612 JEFFERSON AVENUE  
612 JEFFERSON AVENUE, LOUISVILLE, CO 80027

## Foundation/Main Floor Framing Plan

**Roof Framing Plan**

Re: Residential Repair  
612 Jefferson Ave.  
Louisville, CO

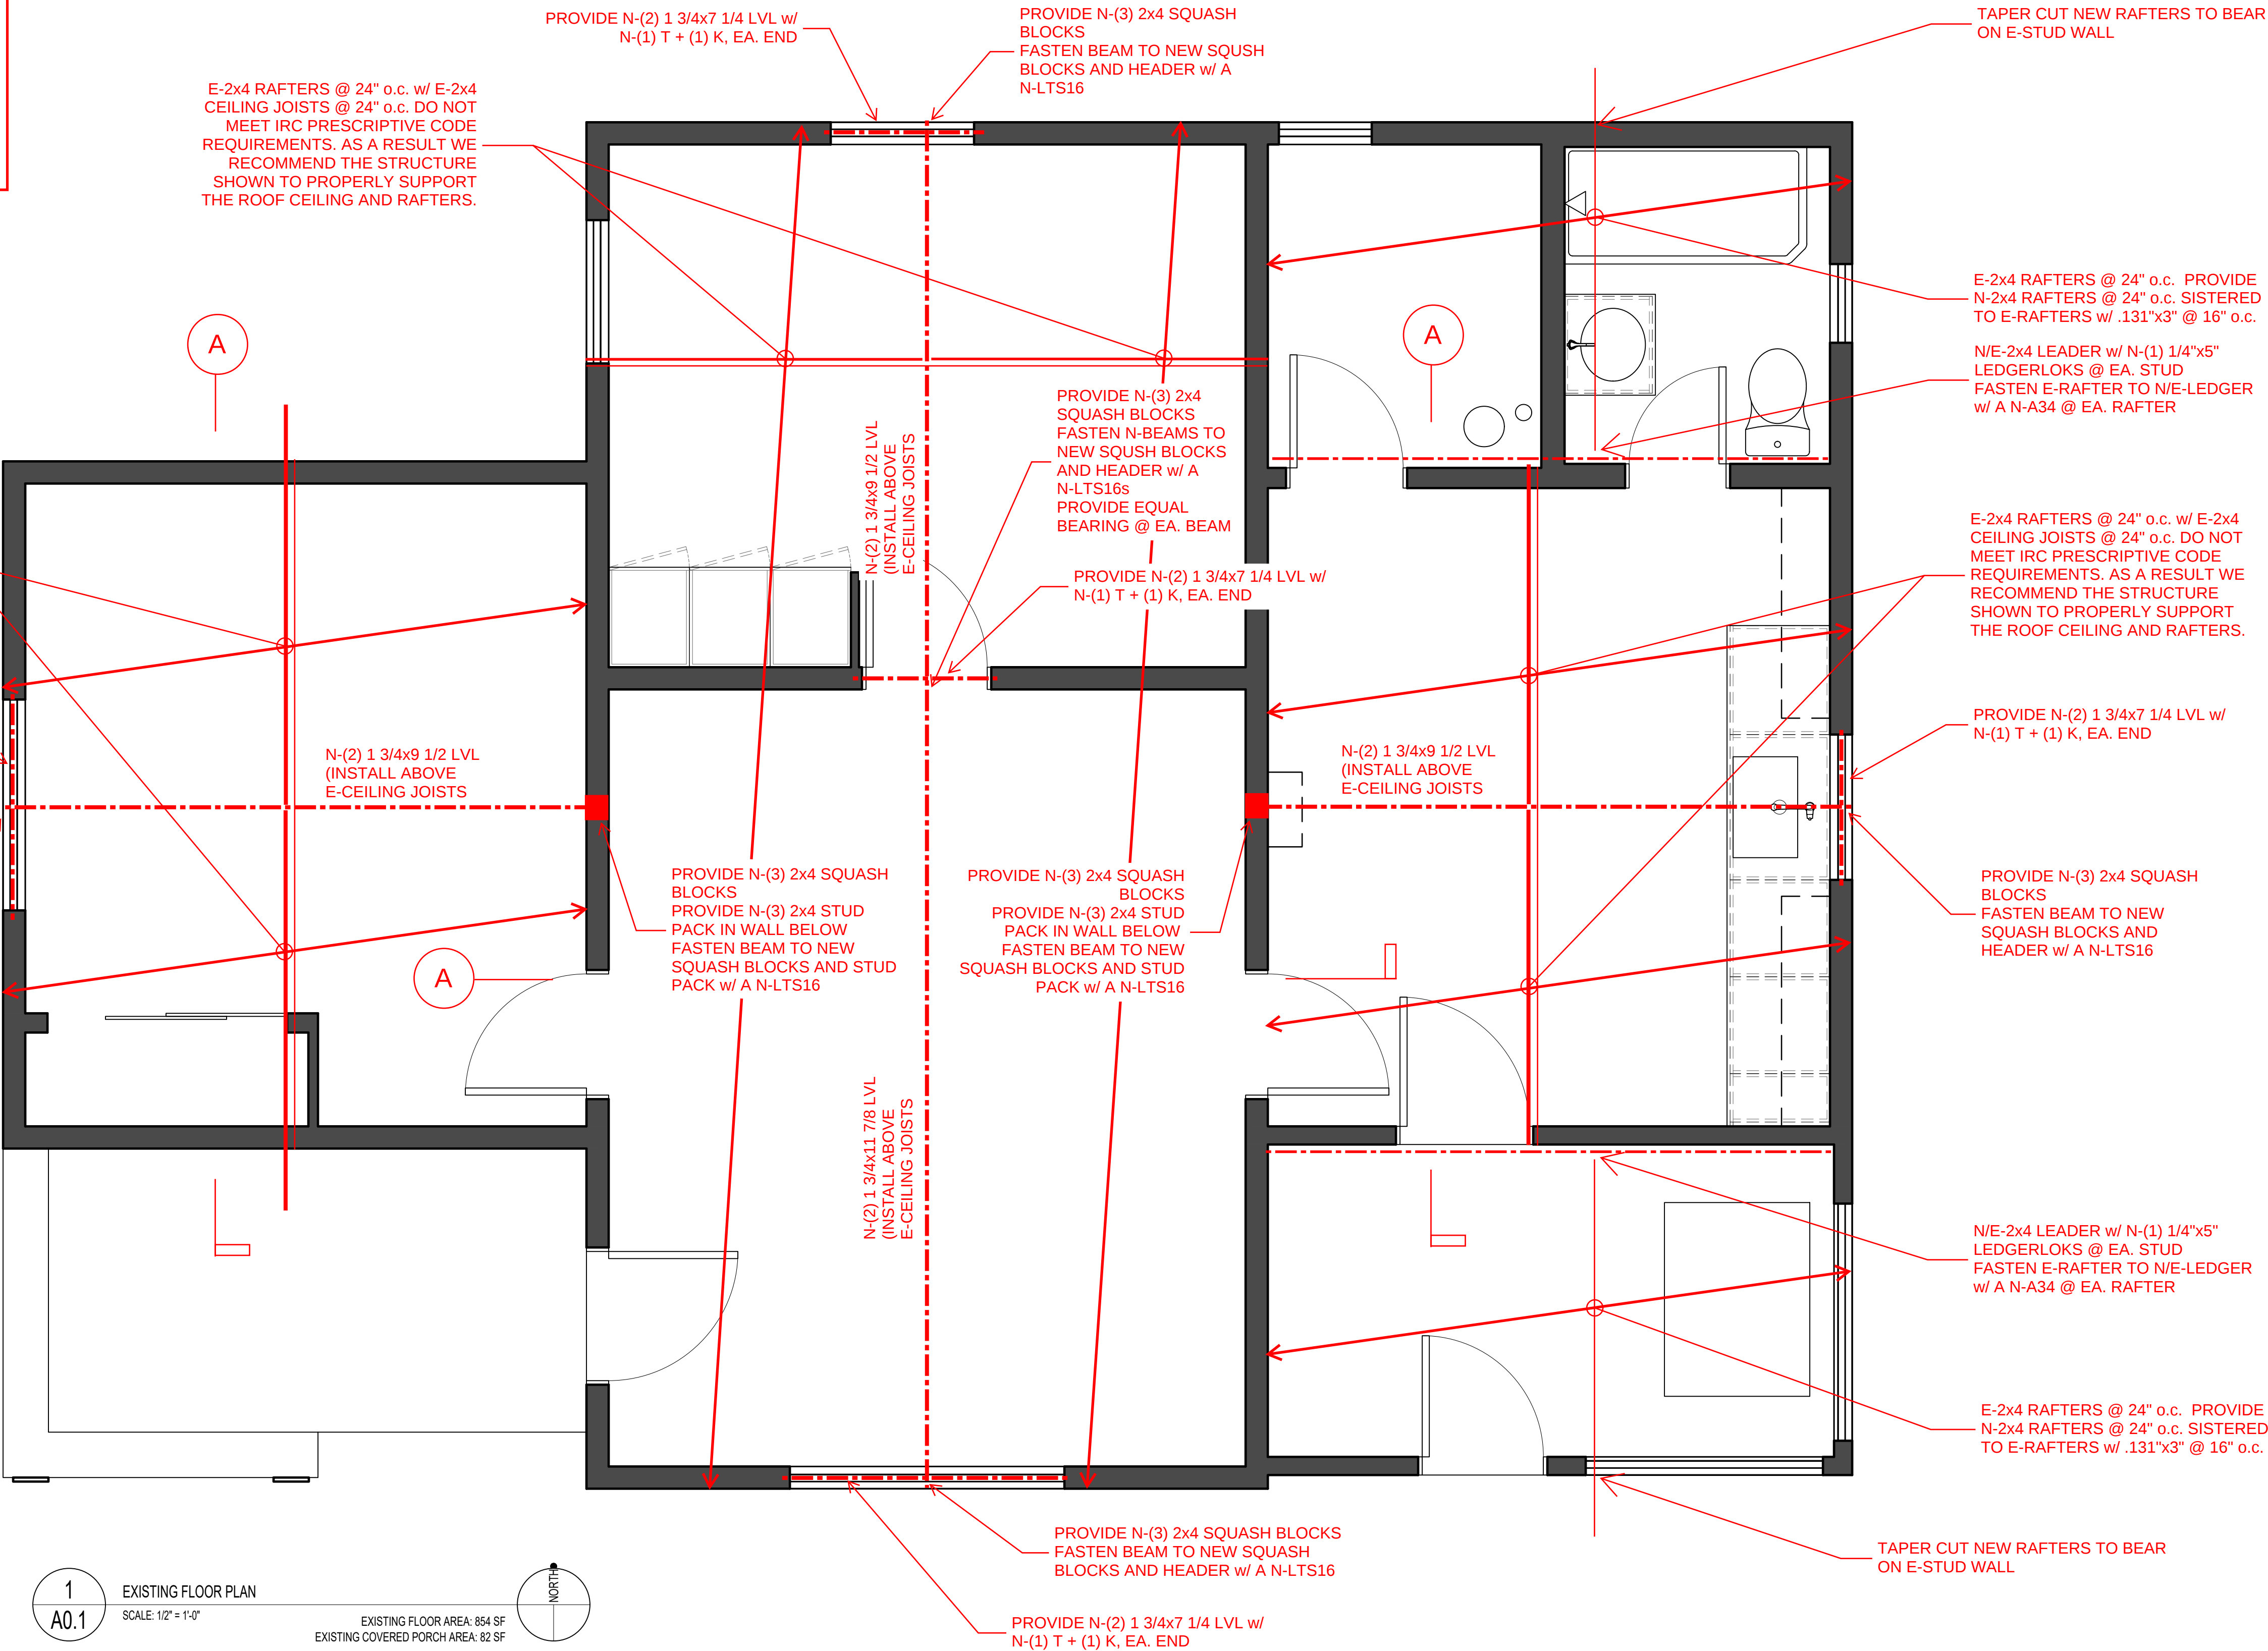
SECTION 'G' DENOTES AN EXISTING FOUNDATION REPAIR DUE TO EXTERIOR FOUNDATION DAMAGE. THIS REPAIR OCCURS AT ALL EXISTING WALLS TO REMAIN.

E-2x6 FLOOR JOISTS @ 24" o.c. FLOOR JOISTS DO NOT MEET MINIMUM IRC CODE DEFLECTION AND BENDING LIMITS, AS A RESULT NEW BEAMS AND FOOTINGS HAVE BEEN ADDED TO REPLACE STACKED STONE, WOOD POSTS AND MASONRY BLOCK

- b. Repair along the outside face of the wall is required to protect the existing foundation from future damage. See the structural section provided.
- c. It is our opinion that several areas of the existing foundation should be removed and replaced. Please see the attached Foundation/Main Floor Plan and Structural Sections for these locations and for construction.

- i. The portion of the foundation below the existing south entrance area/room should be removed and replaced. It is performing poorly, broken and crumbling and continued use will likely result in significant damage to the wood structure above. This includes the south foundation wall and the crawl space wall along the east (southeast portion of the building).

- ii. The crawl space walls at the northeast of the building should also be removed and replaced. The foundations at these locations have sustained significant water damage from the exterior and were further damaged at some point when a new sewer line was installed.

- iii. The east basement wall and the interior retaining walls should be replaced due to improper/inadequate construction. Based on our observation, they do not appear to have been properly built to support the loading from above or to retain the crawlspace soil.

- iv. New footings have also been specified in the crawl space to properly support new beams and posts from above and the existing floor framing above. The purpose of these footings is to properly support structure to meet minimum IRC code requirements. These footings have been designed with an allowable bearing pressure of the 1500 psf. This bearing pressure matches similar bearing pressures used in the buildings directly to the east and west of this building. It is also a common bearing pressure used for spread-footing buildings in the Louisville area.

- b. In the Foundation/Main Floor Framing Plan, we have proposed installing new beam lines to replace the existing beams and at joist mid-span to reduce joist deflection and meet minimum IRC code requirements for deflection.

N-(2) 1 3/4x7 1/4 LVL, DROPPED TO SUPPORT E-FLOOR JOISTS. FASTEN BEAM TO E-JOIST w/ A .131"x3" TOE-NAIL

N-1'-6"x1'-6"x0'-10" FOOTING w/ #5 HORIZ. @ 12" o.c. EA. WAY, 3" CLR. FROM BOT. OF FOOTING

N-(2) 2x4 STUD PACK w/ AN ABU44 POST BASE, STRAP TO EA. BEAM END w/ N-(2) LSTA15

SUPPORT NEW BEAM w/ A N-2x4 P.T. S.P. FASTENED TO E-FOUNDATION WALL w/ N-(2) 5/8"x6" TITEN HD SCREWS TO THE E-FOUNDATION WALL (SPACE FASTENERS 8" APART AND 4" MIN. FROM TOP AND BOT. OF THE E-FOUNDATION WALL

FASTEN N-FOUNDATION WALL TO E-WALL w/ (1) #5x2'-6" DOWEL 6" FROM TOP AND BOT. OF E-FOUNDATION WALL. COORD. w/ GFE IF NEW FOOTING/FOUNDATION IS LOWER THAN E-FOOTING/FOUNDATION. CARE SHOULD BE TAKEN NOT TO UNDERMINE THE E-FOOTING/FOUNDATION.
